**SOLICITATION AMENDMENT
MODIFICATION DE L'INVITATION**

Title - Sujet Upscheek Tashee Trail Construction	
Solicitation No. - N° de l'invitation 5P437-190013/B	Amendment No. - N° modif. 003
Client Reference No. - N° de référence du client 5P437-190013	Date 2019-03-26
GETS Reference No. - N° de référence de SEAG PW-\$PWY-019-8566	
File No. - N° de dossier PWY-8-41204 (019)	CCC No./N° CCC - FMS No./N° VME
Solicitation Closes - L'invitation prend fin at - à 02:00 PM on - le 2019-04-18	
Time Zone Fuseau horaire Pacific Daylight Saving Time PDT	
F.O.B. - F.A.B. Plant-Usine: <input type="checkbox"/> Destination: <input checked="" type="checkbox"/> Other-Autre: <input type="checkbox"/>	
Address Enquiries to: - Adresser toutes questions à: Ngan, Ken (PWY)	Buyer Id - Id de l'acheteur pwy019
Telephone No. - N° de téléphone (604) 671-0219 ()	FAX No. - N° de FAX (604) 775-6633
Destination - of Goods, Services, and Construction: Destination - des biens, services et construction: Parks Canada (PCA) - Upscheek Tashee Trail - Pacific Rim National Park - Ucluelet, BC

This Solicitation Amendment 003 is raised to incorporate Addendum 3, and the associated revised Unit Price Table, Environmental Proc

LAWN DRAINS

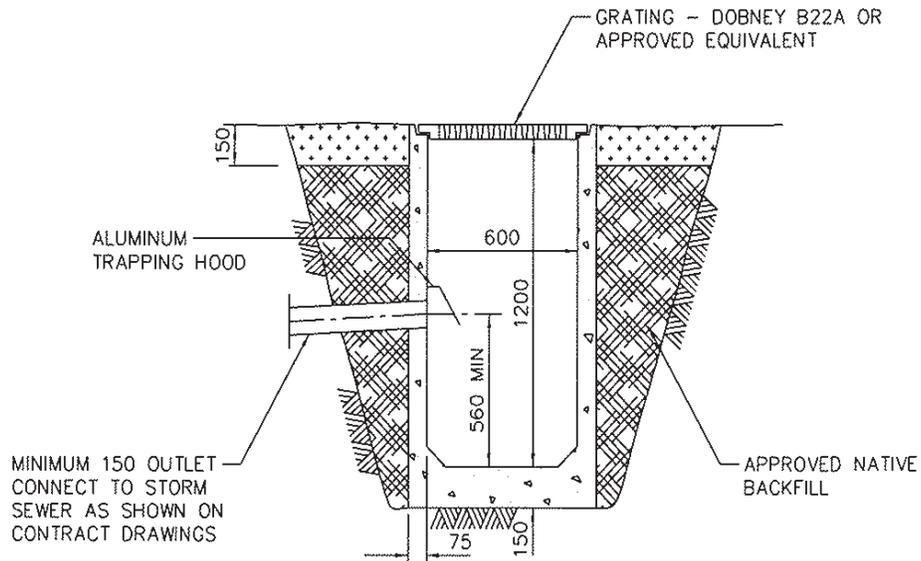
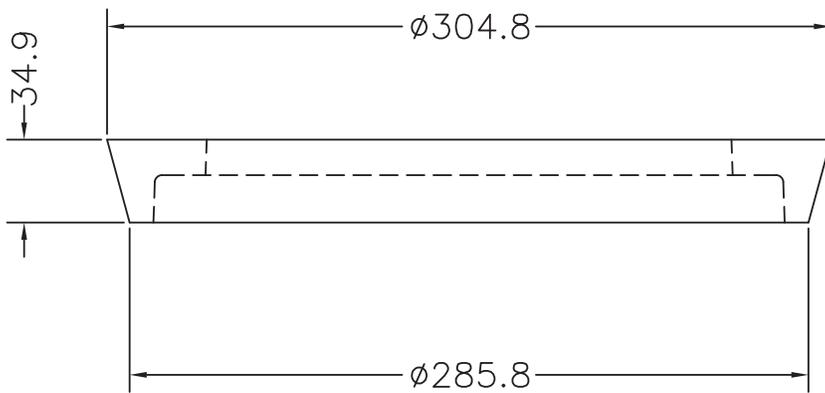
1. **Question:** For pay item #192, 200mm diam. lawn basin grate inlet, please provide locations, detail and specifications for lawn basin grate inlet.
-

Answer: Pay item 192 is revised to 300mm diameter lawn basin as detailed in Master Municipal Construction Documents (2009) Drawing Number S12, Type 1 lawn basin, and Dabney Foundry grate D-2, drawing no. D-2. Both drawings included in this addendum. Lawn basins will be placed at the low points of the swales at the retaining wall locations detailed in the “W” series of the contract drawings and connected into the wall drainage system. The low point shall be determined at time of construction to ensure the actual low point is drained.

3		All Dimensions Shown In Millimetres, Unless Otherwise Noted
2		
1	JANUARY 2016	
	Revision Date	JAIME BOAN Approved
		Title
		SWING GATE DETAILS
		Approved By :
SUPPLEMENTARY STANDARD DRAWINGS		 G.M. Engineering
		DRAWING NUMBER
		SSD-R.36
		JANUARY 2016

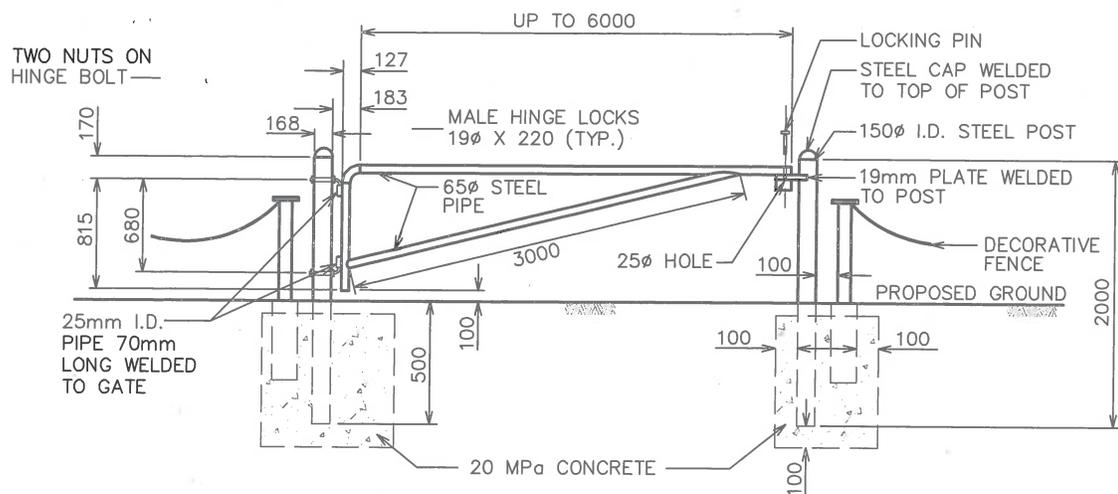
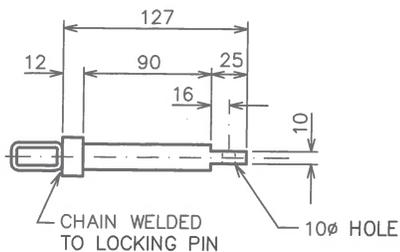
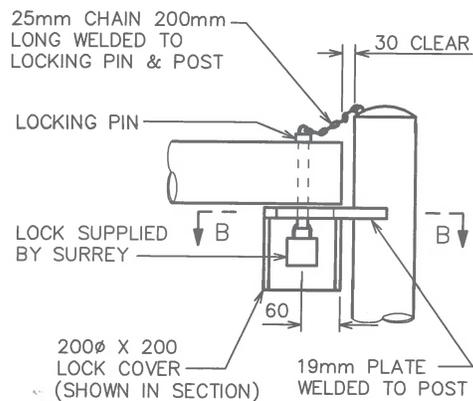
16. Question: Please provide a detail for the forestry gates trail.

Answer: Pay Items 52 (8m wide parking lot gate) and item 53 (5 m wide access gate) are for the supply and installation of each size of metal gate. Specification 05 51 00, clause 2.1.7 provides a generic description of the gates and the minimum dimensions of the steel components. A typical swing gate design is included in this addendum. Alternate designs providing similar security and durability are acceptable.
